Mountain View Replat "A"

City Plan Commission — February 26, 2026

CASE NUMBER/TYPE:	SUSU26-00001 – Resubdivision Combination
CASE MANAGER:	Alonso Hernandez, (915) 212-1585, HernandezJA5@elpasotexas.gov
PROPERTY OWNER:	CG ELP Dyer LLC.
REPRESENTATIVE:	SLI Engineering, Inc.
LOCATION:	North of Hercules Dr. and East of Dyer St. (District 2)
PROPERTY AREA:	1.31 acres
VESTED RIGHTS STATUS:	Not Vested
PARK FEES:	pending
EXCEPTIONS/MODIFICATIONS:	Yes, see following section
ZONING DISTRICT(S):	C-3 (Commercial), C-4 (Commercial)

ATTACHMENT 2

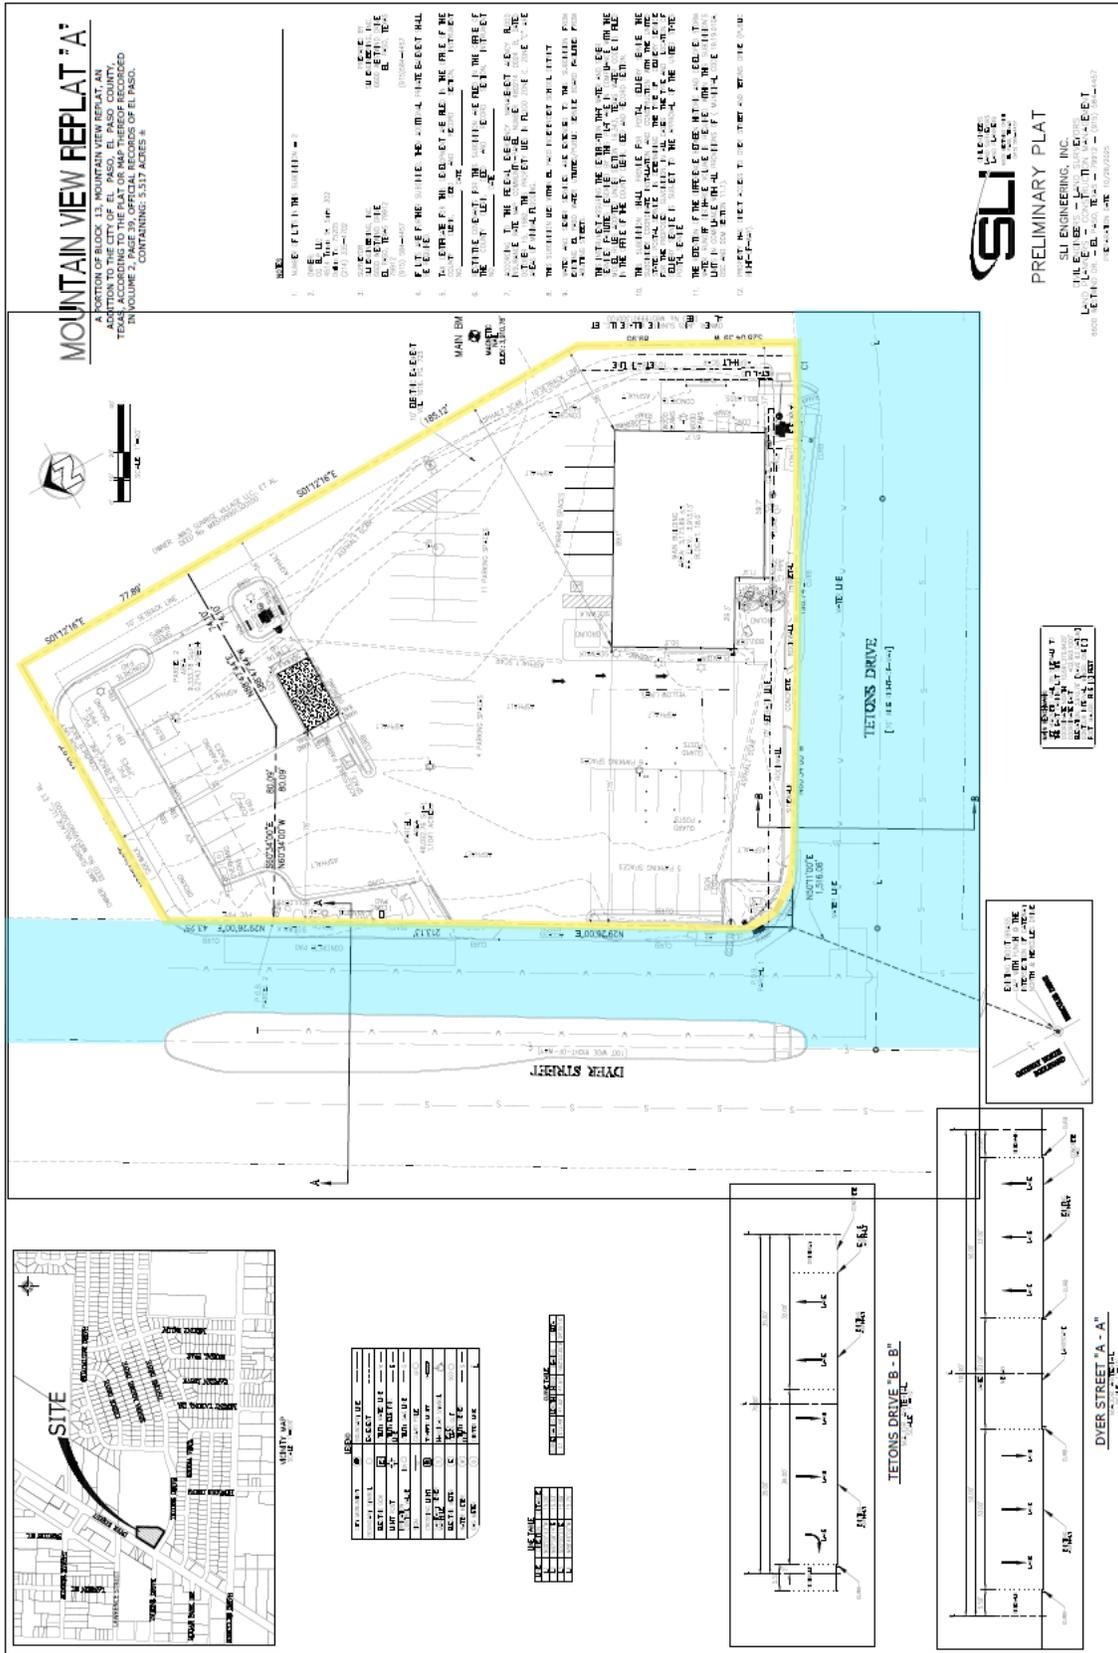
6. Tetons Dr. is a collector street, not a major street. Please update the cross-section title to reflect the correct classification.
7. Label all buildings or structures on the preliminary plat to indicate whether they will remain or be demolished.

8. Provide the block and lot number on the face of both the preliminary and final plats. Staff recommends Block 1, Lot 1 and Block 1 Lot 2.
9. Staff recommends removing the “Parcel 1” and “Parcel 2” designations from the face of both the preliminary and final plats to avoid confusion.

10. Indicate the direction of flow for all watercourses on the preliminary plat and include the on-site ponding location.
11. Provide address or proposed address for each lot within the subdivision on both the preliminary and final plats.

12. Remove the frame lines from the viewport to maintain clarity on the preliminary plat.
13. The acreage shown on the preliminary plat does not match the final plat and deed. Please revise for consistency.

14. Provide the restrictive covenants, as referenced in Plat Note No. 6 on preliminary plat.

1. Show proposed drainage flow patterns on preliminary plat for storm-water runoff into on site detention ponding area(s), identify the excess discharge location(s).

2. Show and Label drainage flow patterns on the preliminary plat and identify the final location of all the stormwater runoff.
3. On the preliminary plat, show and label the proposed pond location within the lot. Any proposed ponding area shall have enough capacity to hold the developed runoff for a designed 100-yr storm event.
4. Lot owners are responsible for maintaining adequate provisions to accommodate all stormwater runoff generated from their respective lot.
5. At the improvement plan stage, provide protection to the subdivision from all offsite storm water runoff that may have an adverse impact on any improvements and convey the existing watercourse through the subdivision.
6. Revise line and curve tables for elements that are not part of the final and/or preliminary plat.

ATTACHMENT 3

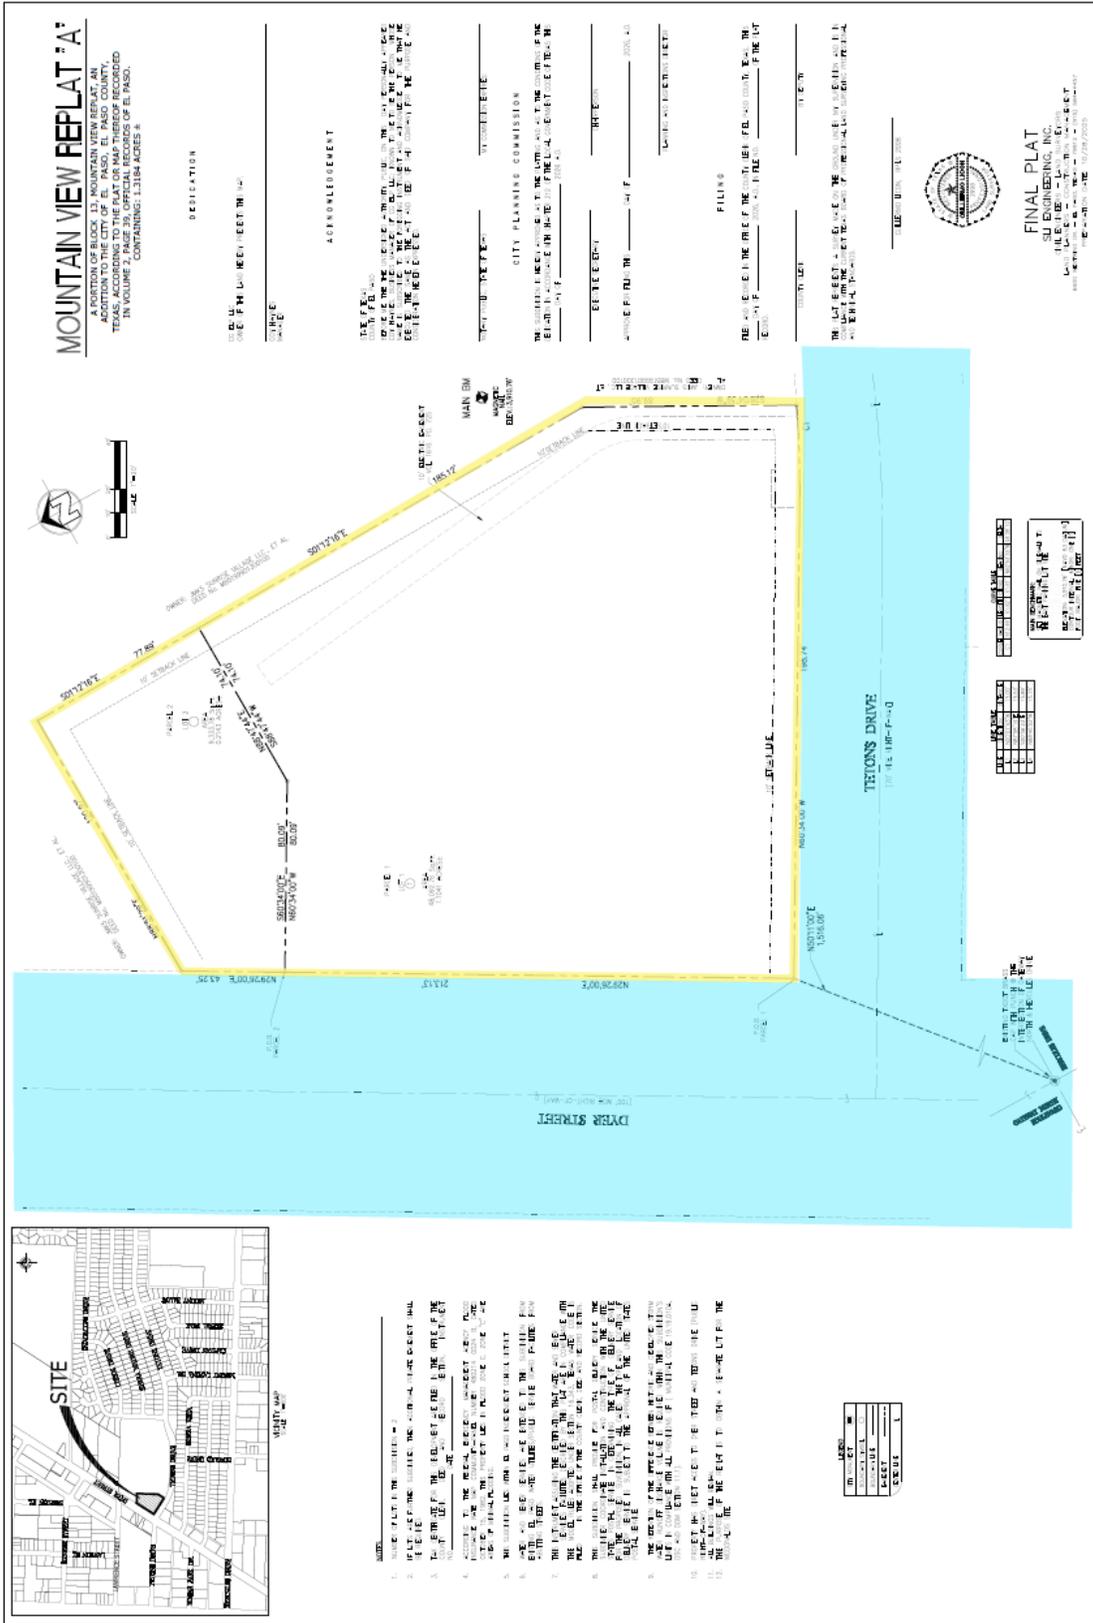
Please add a 15' wide easement along Dyer St. We have an existing line.
